#### UTAH DEPARTMENT OF TRANSPORTATION

**SUBJECT:** Standards Committee Meeting Minutes and Next Meeting

2. 800 Series Standard Drawing Conversion Process (Agenda Item 2) – Item presented by Richard Clark for John Leonard.

#### Update, consolidation, and conversion of Old 800 Series Drawing 815-1.

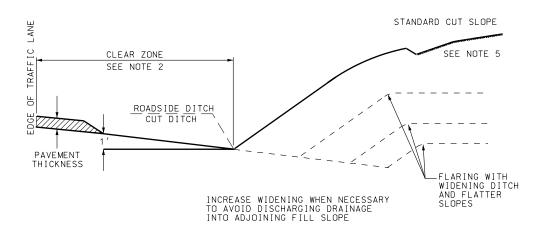
- Drawing 815-1 was covered next. Jim asked Jason to clarify the statement in the fifth paragraph in John's notes, dealing with the cut ditch. Dave said that having a cut ditch at the top of the cut has exacerbated some slide conditions. He gave an example of the situation and explained the situation. Sterling commented on the reverse of the situation. Dave said that we have been using this application for years and it seems to have helped quite a bit in both situations. He added that in isolated conditions it hasn't helped. He recommended giving the designer some flexibility given the situation. Jim asked Dave to work with John to make the needed changes.

- There was a question on the note below the Cut Ditch Flaring Detail of 815-1. The recommendation was to send it back to John for clarification.
- There was no significant discussion on 815-1A. The Committee agreed with John's assessment of the Region One request, referenced in the handout.

Region One has requested a review of the use of the cut ditch at the top of a cut when the surface drainage is towards the cut. This is reflected in both the drawing of the cut ditch flaring detail, and in Note 5. This detail and note is on many additional sheets. It is there to catch the drainage as is comes down the slope, and prevent erosion. There is a belief that sometimes it is better to allow the drainage to sheet over the cut rather than concentrating the runoff in on spot or ditch. We can add at the end of Note 5 the words 'where needed' or 'as required', which would leave some flexibility up to the designer. We all agreed that we would abide by any decision by Dave Nazare's group and that of the Committee. Any decision would be applied to all applicable sheets.

**Action Item:** Dave to address cut slope issues with John on drawing 815-1 prior to presentation for approval.

The rounding detail will be modified to add the words 'or fill' to reflect its use in both applications, not just a cut. (Minor)

The title will be modified to reflect there is a benched slope detail. (Minor)

The benched slope detail will have the small print under the title removed. This will allow the designer to determine which is the best method of creating the slope, and reference the detail as necessary. Currently, the way it is written requires all slopes to be built this way. The practice in the field is to use different methods as appropriate.

#### Update, consolidation, and conversion of Old 800 Series Drawing 815-1A.

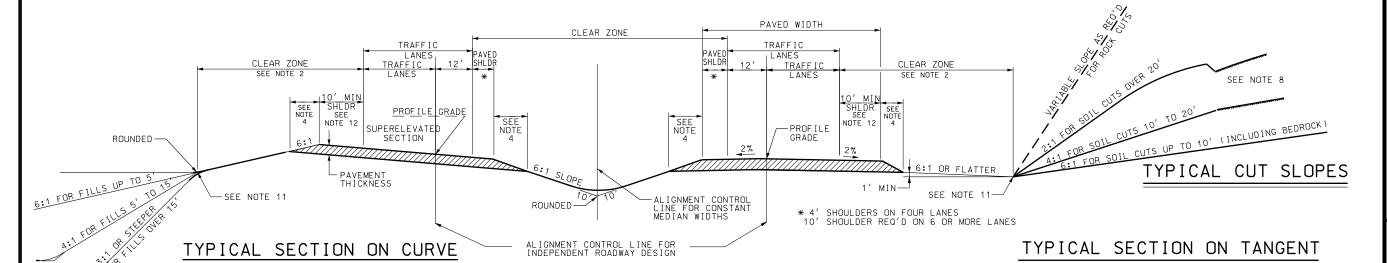
- Jim asked for comments on the proposed Note 13 to 815-1A. Jason referred to something about edge of paved shoulder to edge of paved shoulder. He didn't know why the note was being added. Jim said that John would have to address that at the next meeting.

We will add a note (13) that says 'RANGE OF SUPERELEVATION IS THE PAVED WIDTH.' This will provide for consistency of design. (Minor)

#### Update, consolidation, and conversion of Old 800 Series Drawing 825-1.

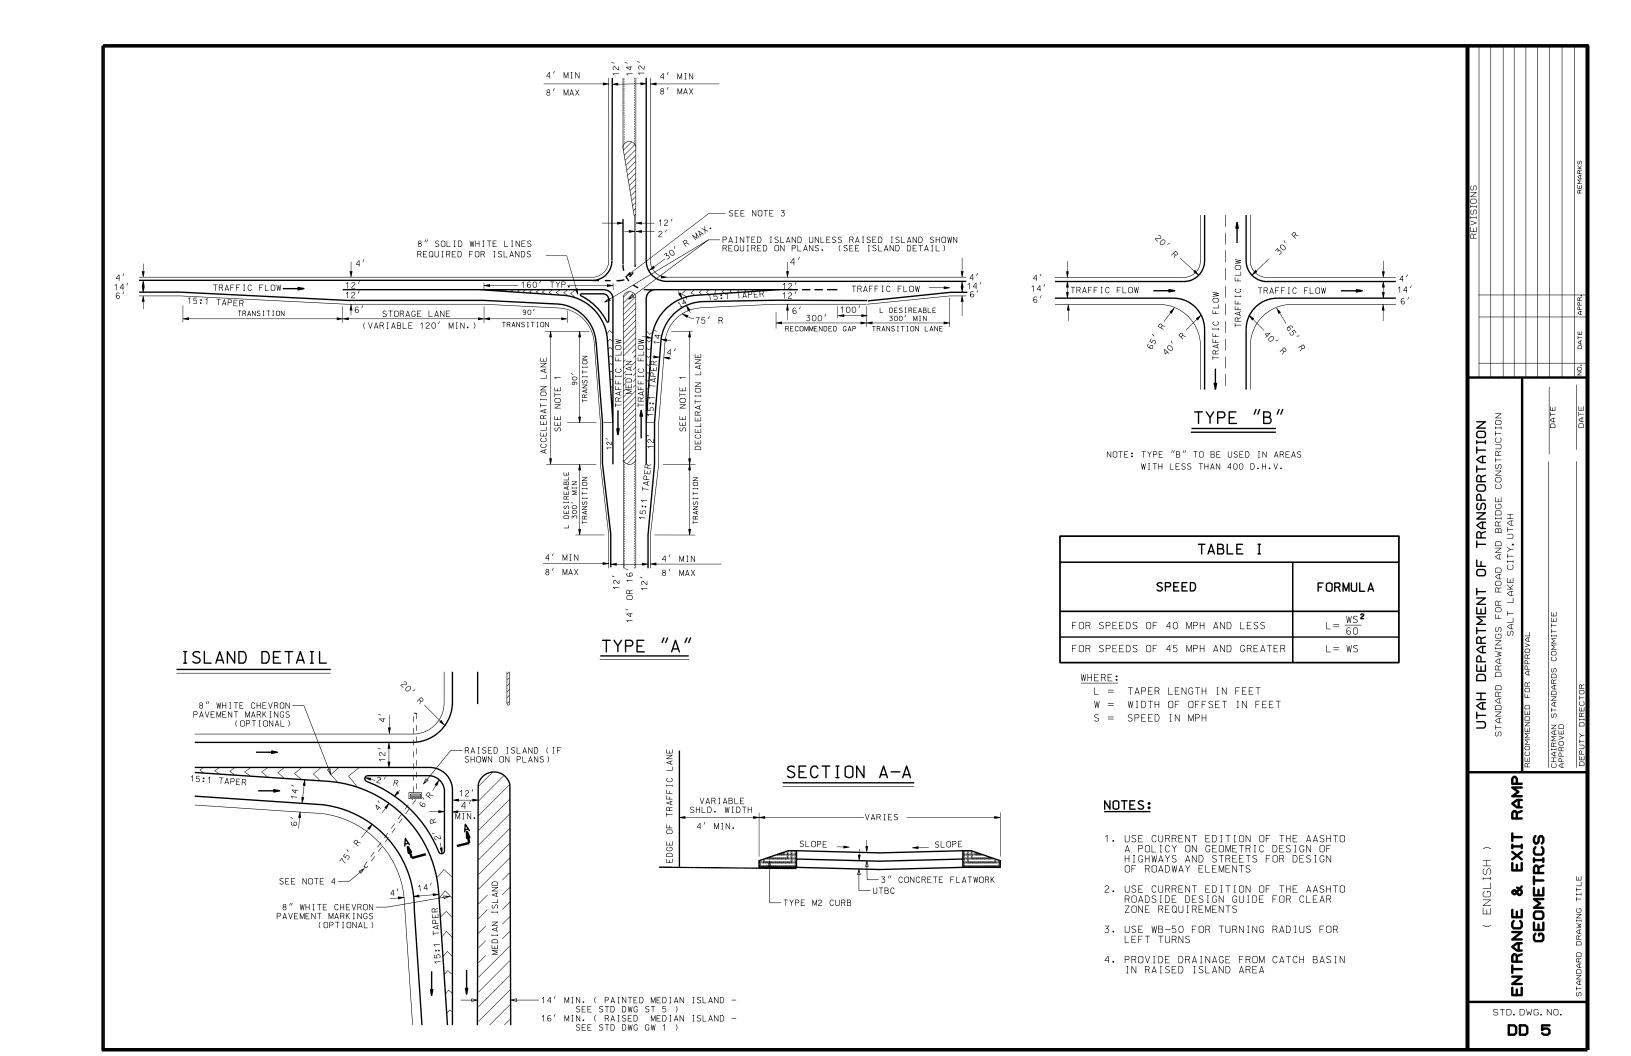
- There were no comments on 815-8.
- On 825-1, Jim asked Richard if painted islands used chevrons and if it were a requirement of MUTCD or something we have done from a safety standpoint. Richard said it is not required. The MUTCD requirement is to paint the nose but UDOT has elected to do that in some cases according to Richard. Jim asked if there is any research or evidence that says that is safer. Are we spending money on what we believe to be safer? Richard said they could look into it. The drawing needs to be brought back. Jim concluded by saying that we want to show the most cost effective option on Standards, not always the optimal option, having our people go from there.

**Action Item:** Traffic and Safety to look into the use of chevrons in relation to safety and cost savings on drawing 825-1 prior to presentation for approval.

#### Update, consolidation, and conversion of Old 800 Series Drawing 805-3.

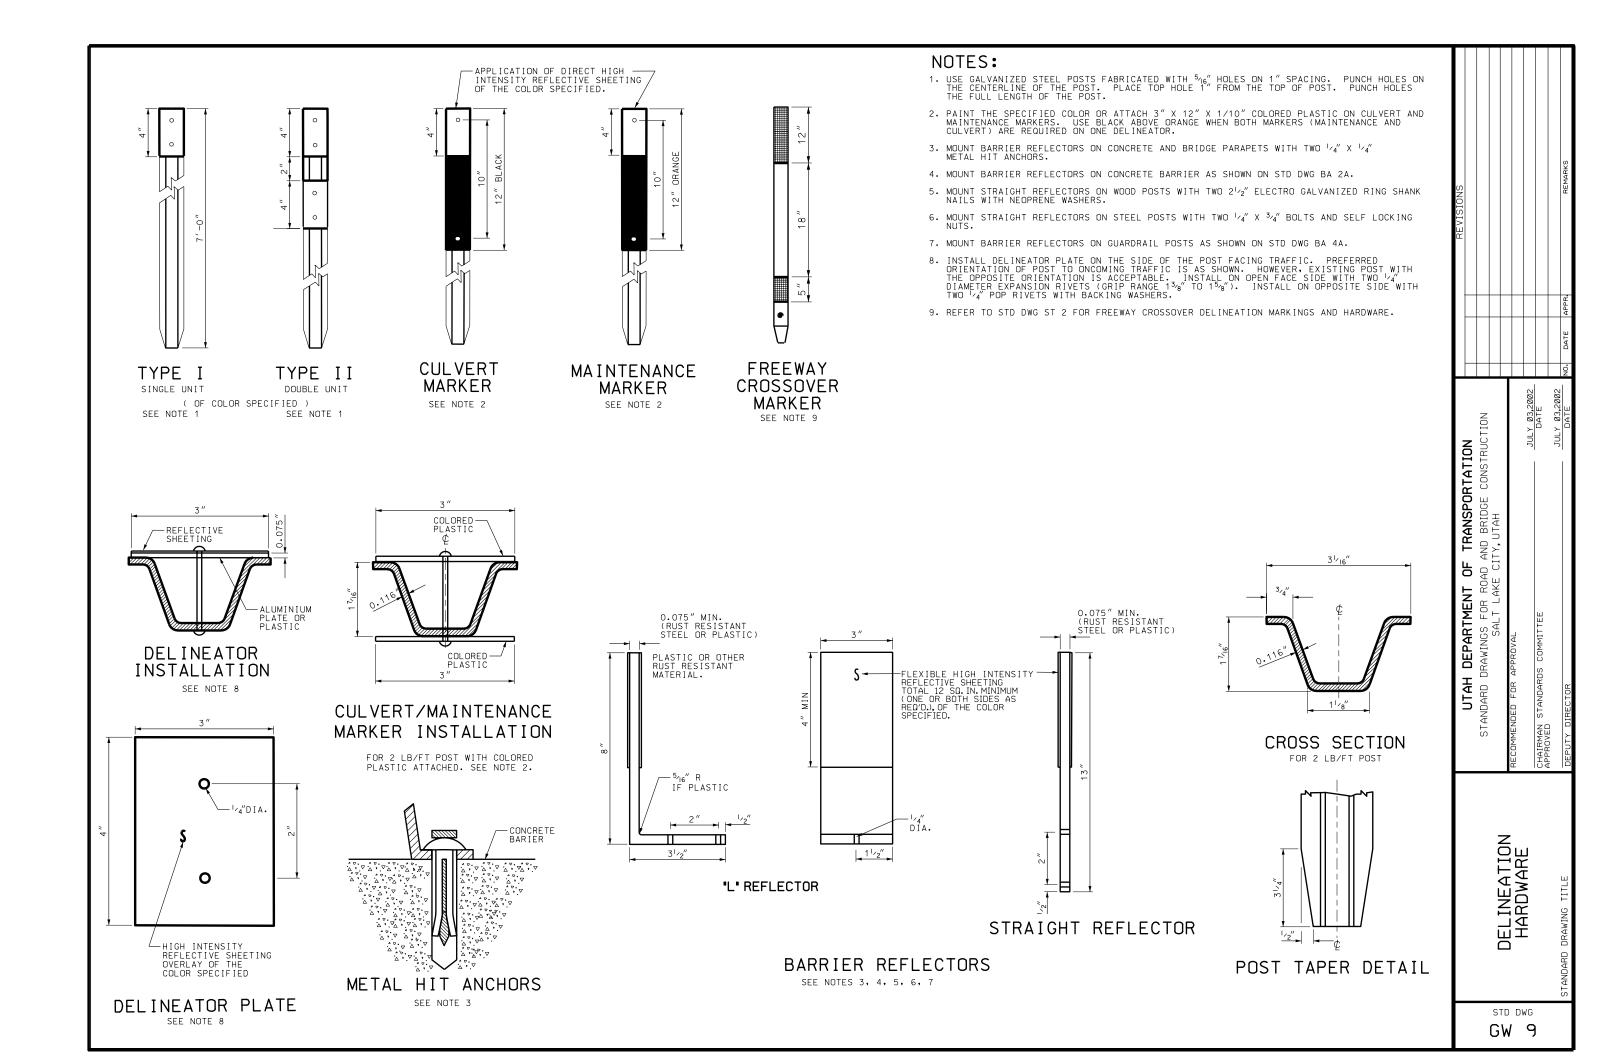
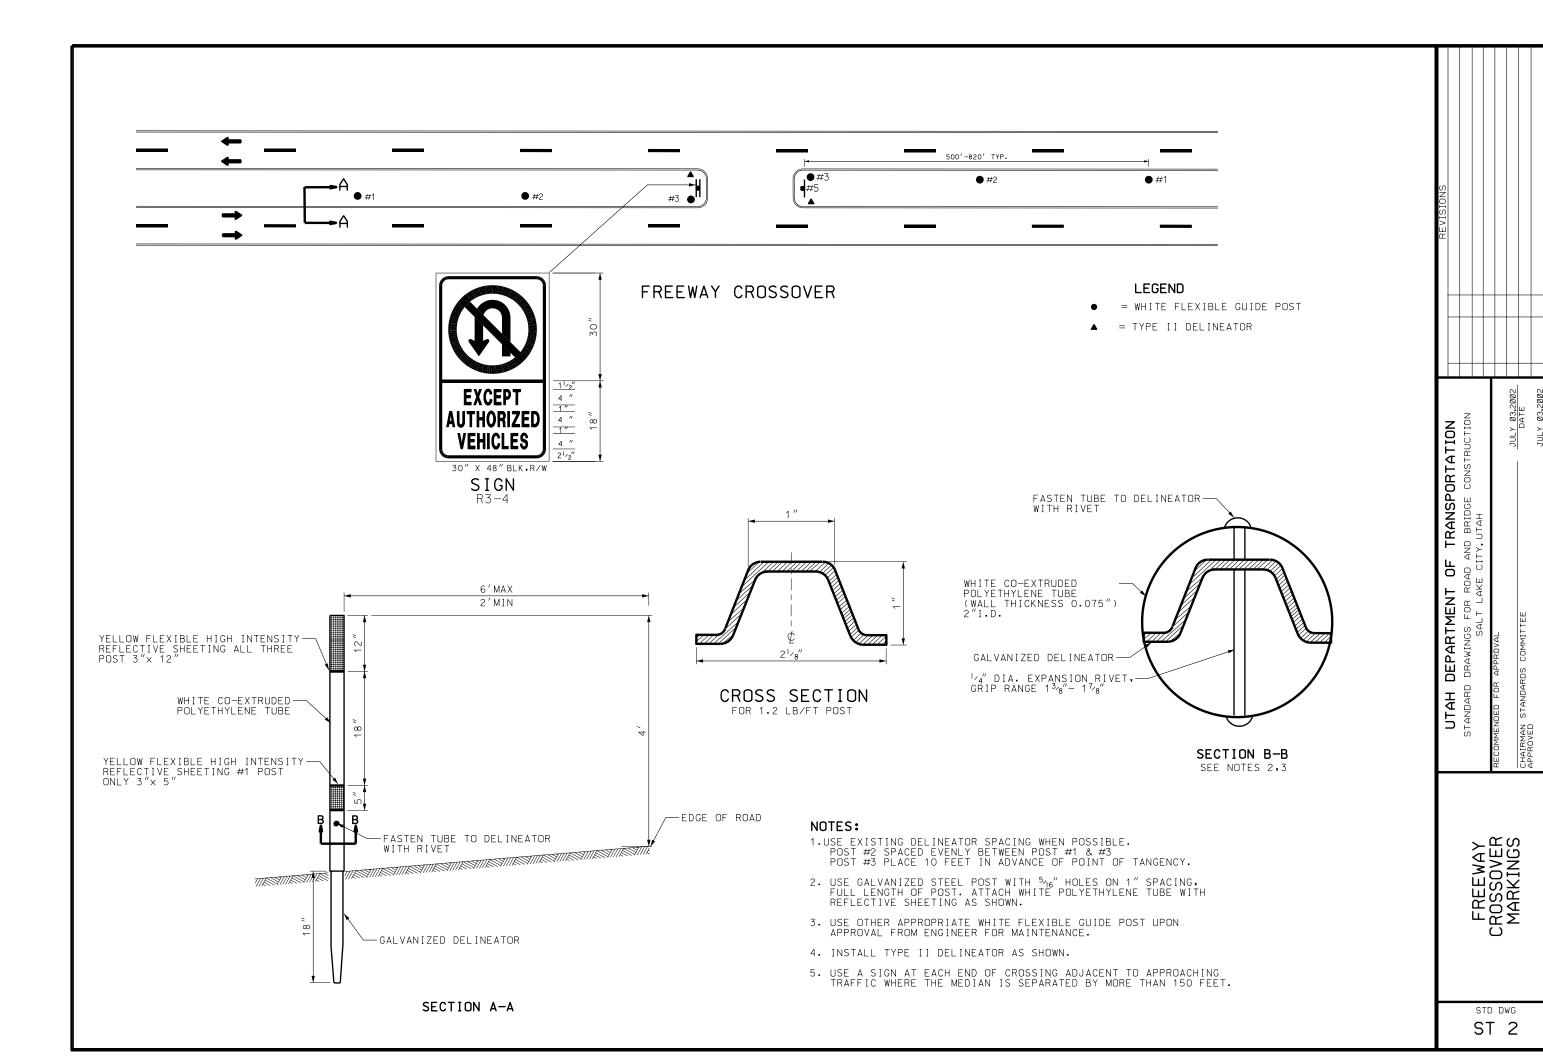
- Jim asked for comments on 805-3. He commented to Sterling that he found it interesting to see the double turnaround on the drawing, adding that he didn't remember seeing those being built. Sterling commented on note 13 of the drawing but didn't think they were used very much any more. Sterling said interchanges are used now. Sterling said it might be too risky to make a U-turn using the crossover. Jim asked Sterling if he had a suggestion for a change to the drawing. Sterling said if the double crossover is not being used then it should be taken off the drawing.

- Continuing with the drawing review Jim asked if there were any additional comments on 805-3. Someone asked why do we even have double crossovers. Farrell said he didn't know. This is an item that needs to be answered. Jim asked if this is a new standard. Barry checked the metric version. The detail was on the drawing approved in March 2001. Barry said that the notes and some of the details appear to be different. In response to a question from Jim, Abdi said he has never built a double crossover, but has built the single crossover. He didn't know the radius in response to an earlier discussion.

- Jim said 805-3 needs to be brought back so John can address the questions. Addressing Sterling, Jim said he has concerns on this drawing. He asked Sterling to take the charge on making sure the drawing addresses all Maintenance needs.

**Action Item:** Sterling to address all Maintenance needs on drawing 805-3 prior to presentation for approval.
